FINAL PLAT OF WOODLAND LAKES ESTATES AN ADDITION TO WICHITA, SEDGWICK COUNTY, KANSAS

Re: S/D 95-59 - WOODLAND LAKES ADDITION (Revised Final Plat)

Re: S/D 95-59 - WOODLAND LAKES ADDITION (Revised Final Plat)

CASE NUMBER: S/D 95-59 WOODLAND LAKES ESTATES

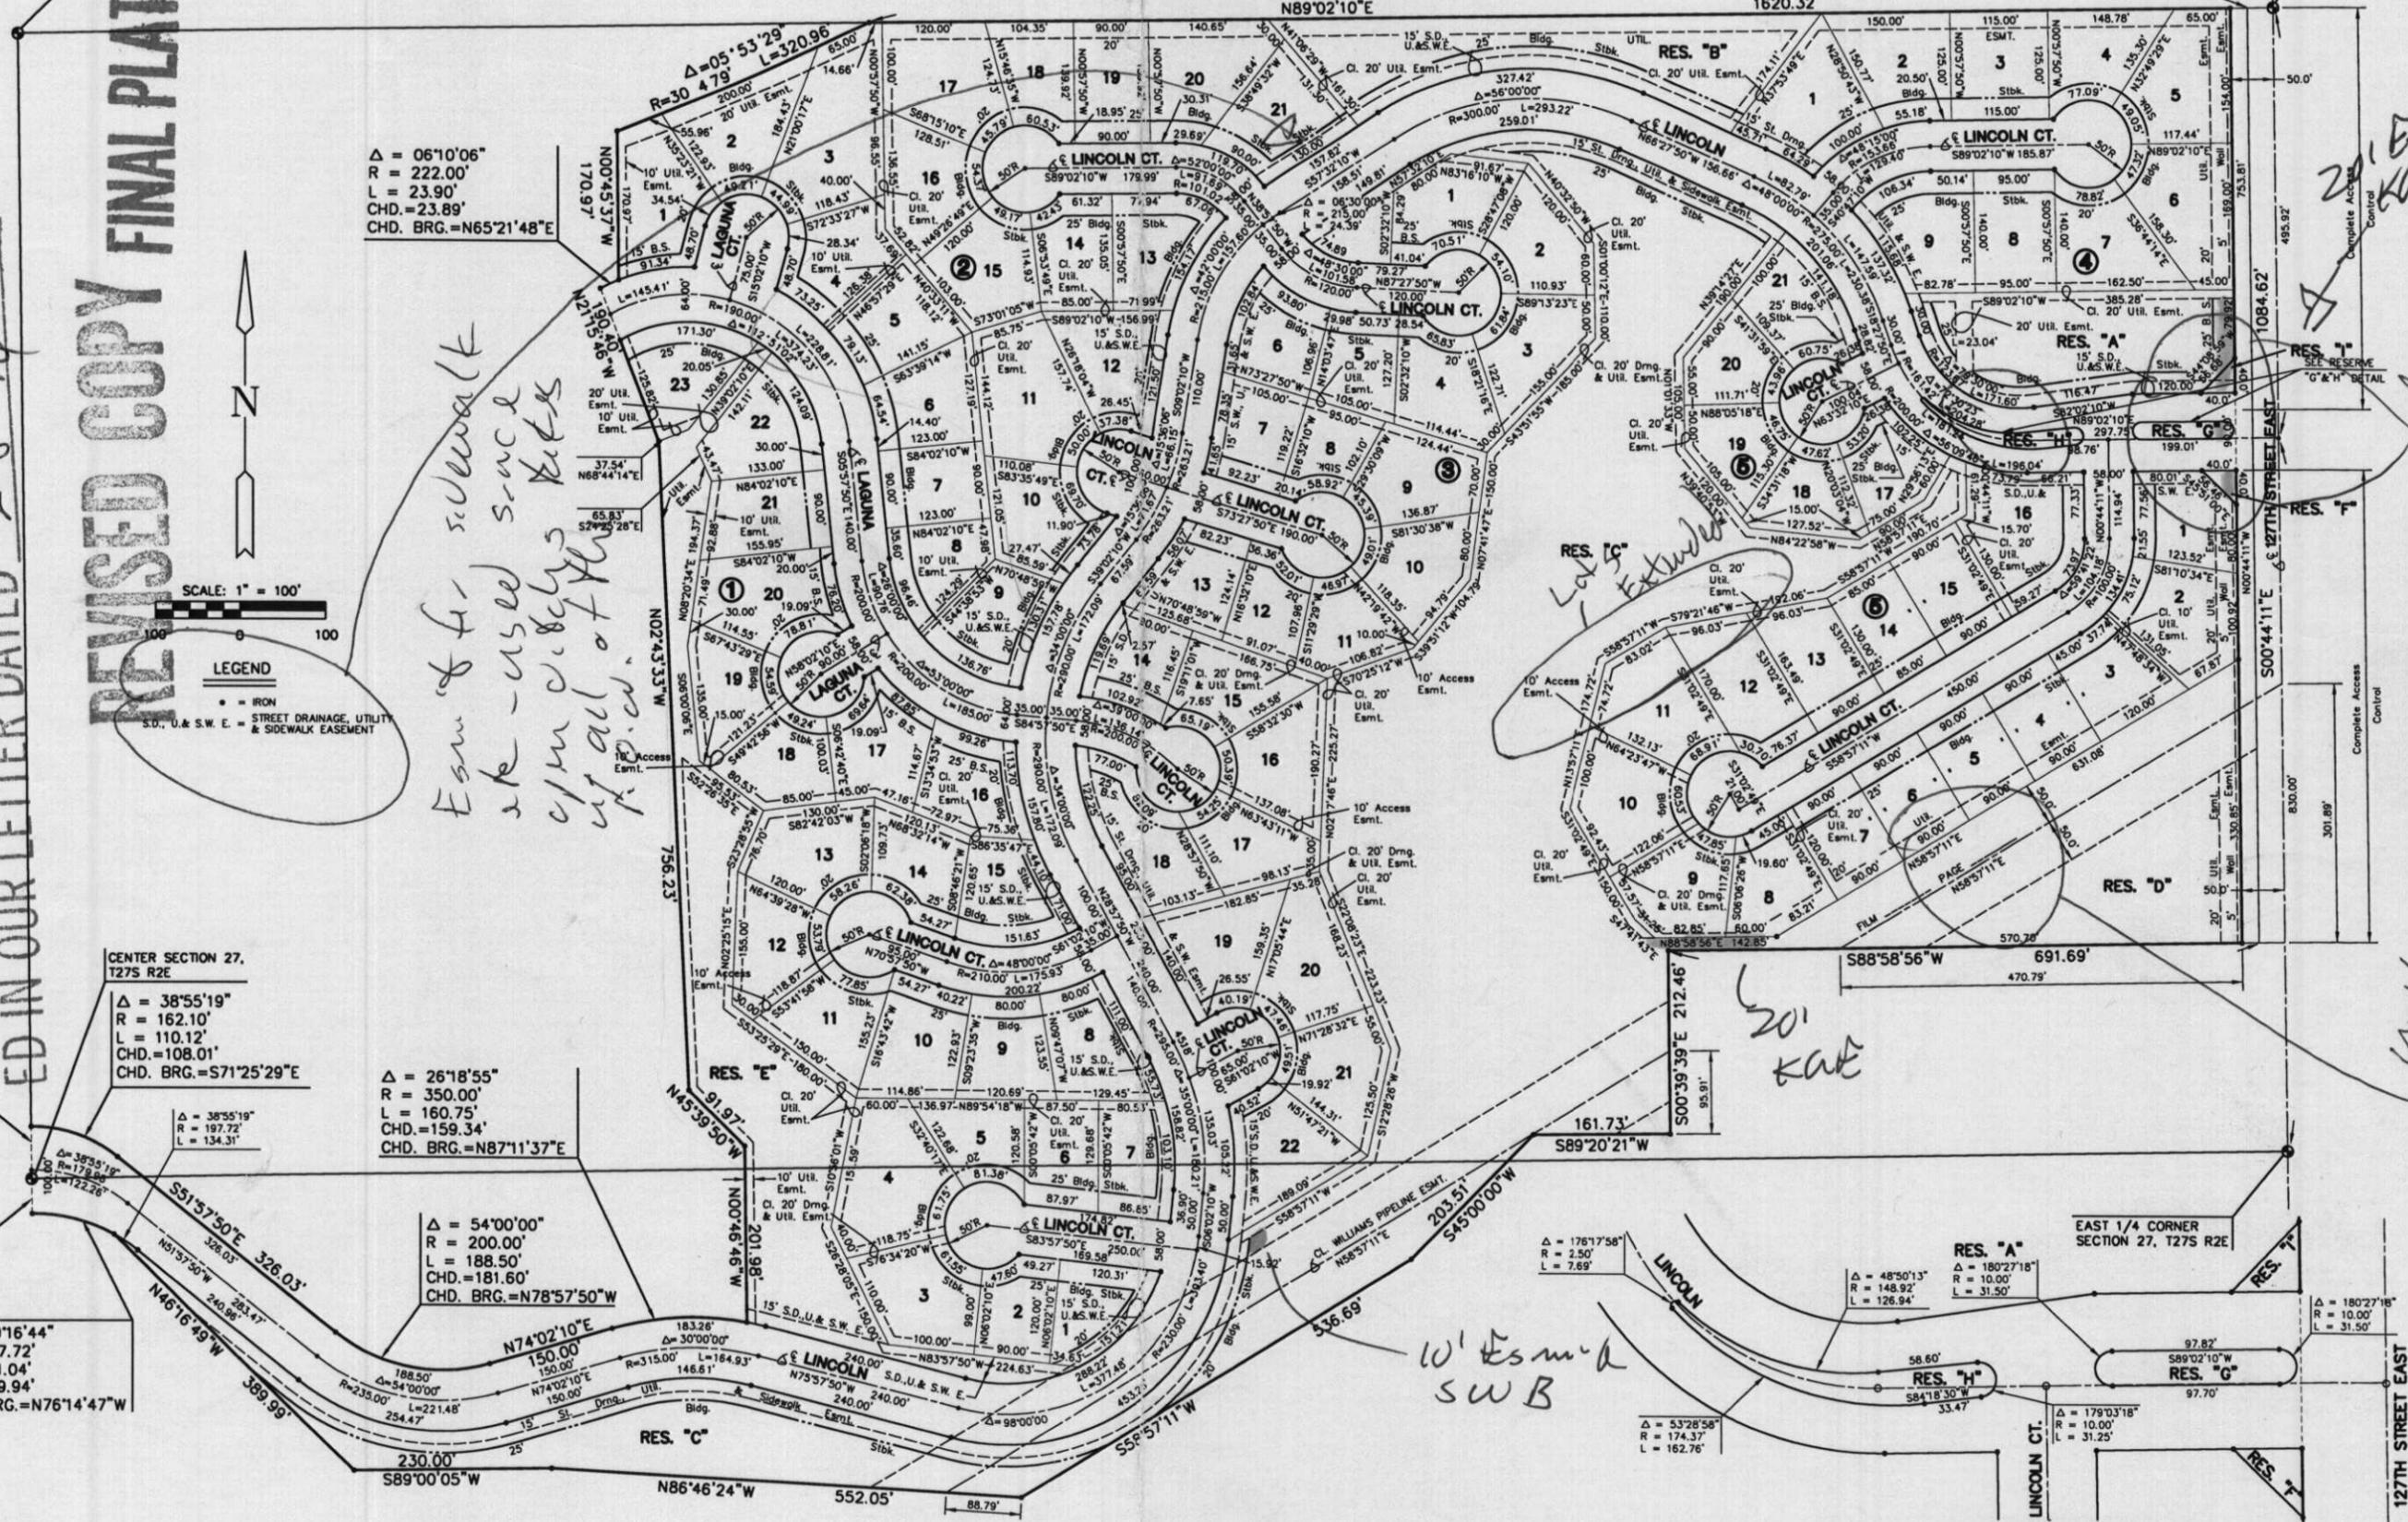
*House by increasing # of lots
from 88 to 96*

*Estm of fr sidewalk
are used since
c/pm circles kids
at all of the
H.O.W.*

*W' Estm'd
SWB*

*20' Estm'd
20' Reserve
G & H Detail
will set the
doc. containing
recorded & show
G. Res. Added
but not final - a new
H.P.*
